Land Use Final Decision

File number(s): DR 22-17 & SA 22-09

Through a Design Review application type, the applicant proposed site redevelopment of a motel site developed in 1986 and presently occupied by the La Quinta Inn & Suites by Wyndham Woodburn motel through addition and remodel into a Holiday Inn Express (HIEX) of 84 rooms with 86 off-street parking spaces and with site upgrades including landscaping and wide walkways to public sidewalks.

Street Adjustment SA 22-09 was to keep the Arney Road landscape strip 6 inches narrower than the standard, that is, 5.5 feet (ft) including curb width instead of 6 ft including curb width.

05 EXTERIOR ELEVATION - SOUTH
 3/32" = 1'-0"

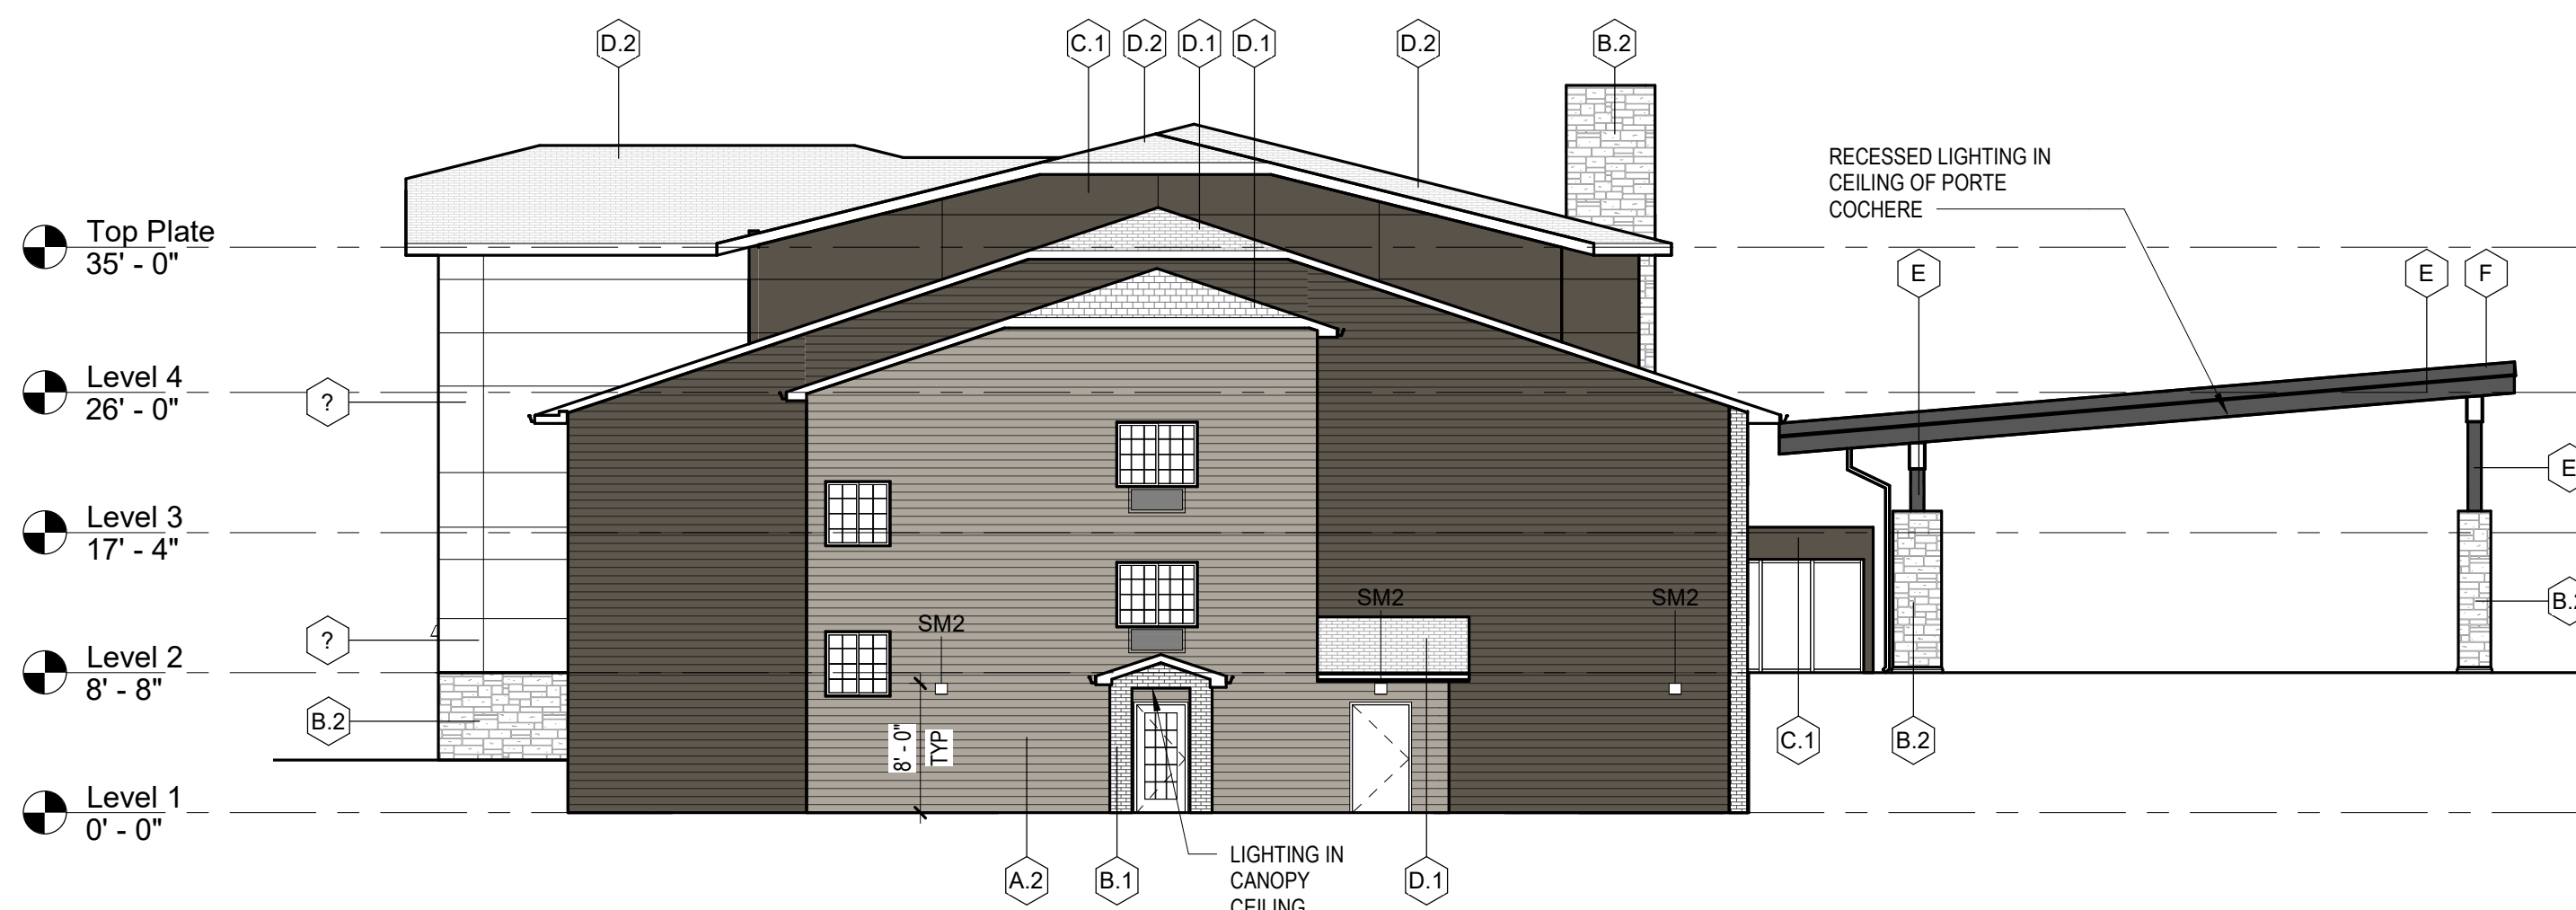
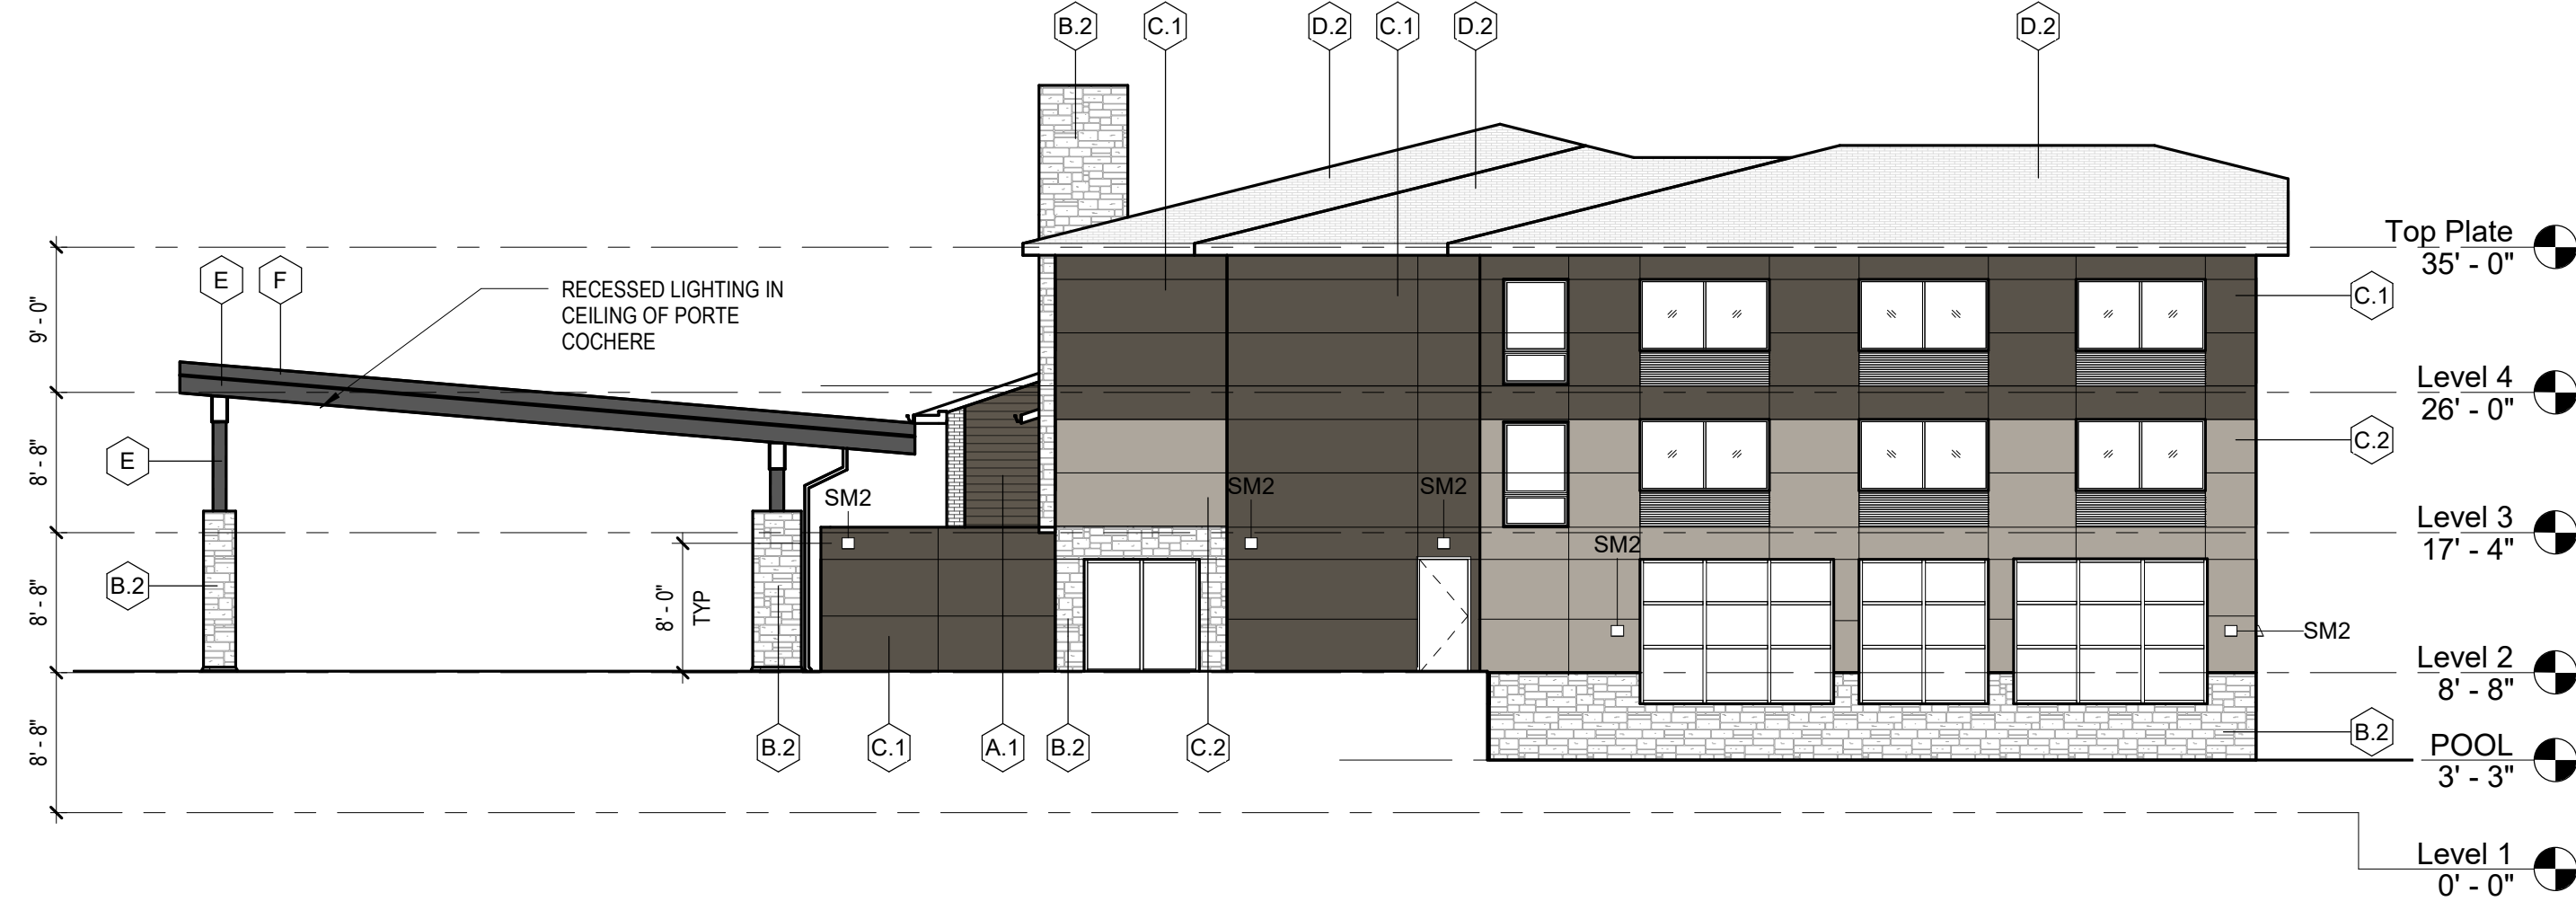
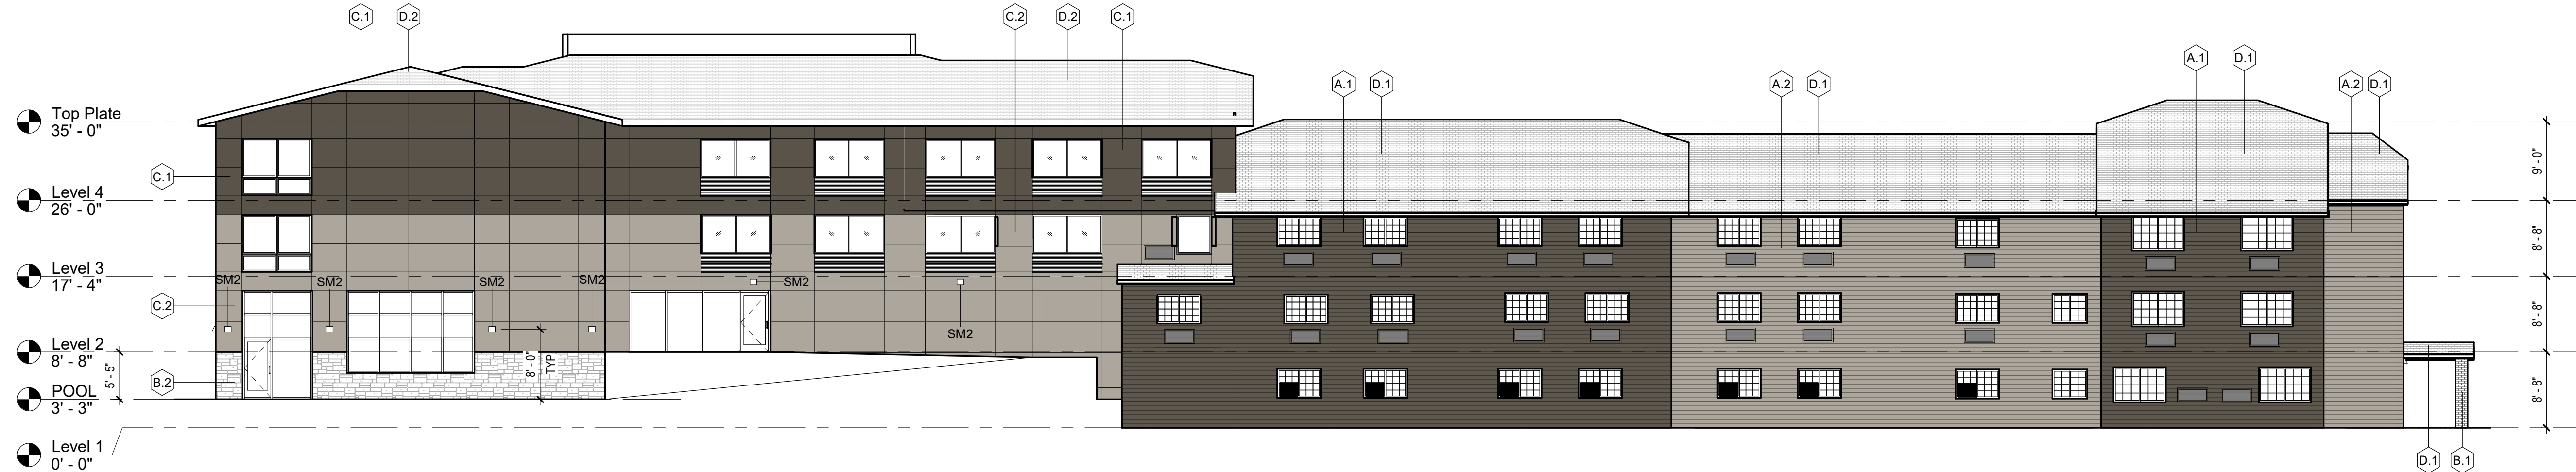
- a. Fenestration/glass/glazing/windows: WDO 3.07.06B.2b(1) (30% glass) shall be applicable as a standard on min one of the two street-facing facades, south/SE and/or north/NW, and 25% shall be the standard for the other facade. Transparency required.

- (1) At the main guest entrance / south/SE façade, 8 ft narrowest dimension and 64 sq ft min area;
 - (2) At the end of the Arney wide walkway at the dining room side door / north/NE façade, min depth 4 ft, min width 7 ft.
Min dimension is applicable to any of dimension parallel with or perpendicular to the building. If and where there are posts, min dimension is measured between main wall plane and inside edges of posts.

Figure 63 Preferred Service Plan Bus Stop Changes

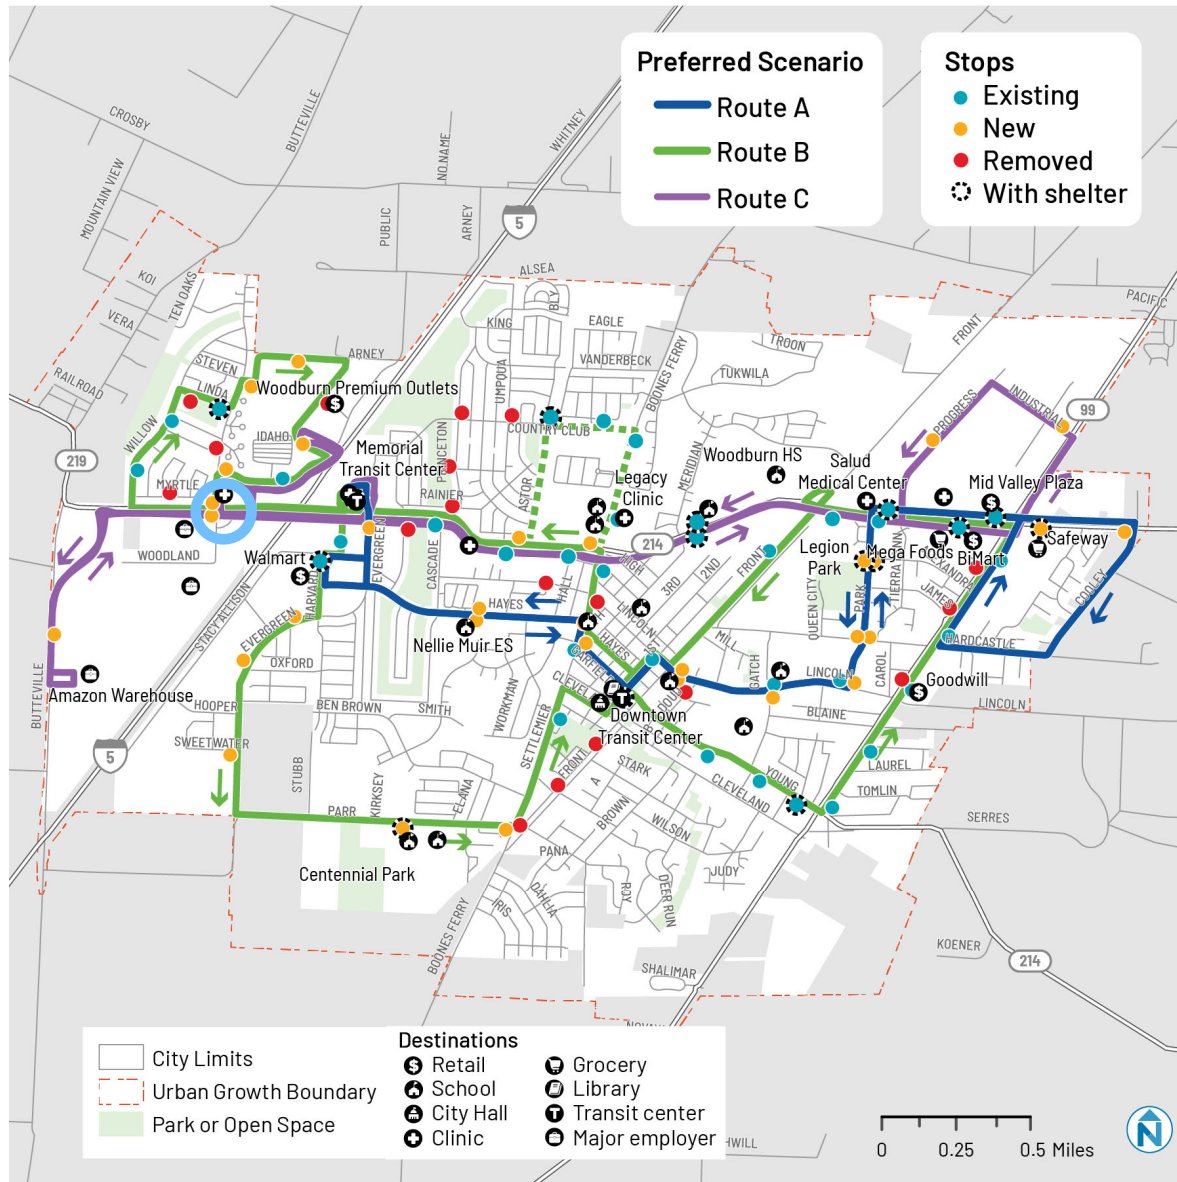
T-T1. Bus shelter / enhanced bus stop: To conform with WDO 3.01.09B, the developer shall pay an enhanced bus stop fee per Attachment 202. [TDP Figs. 63 & 68]
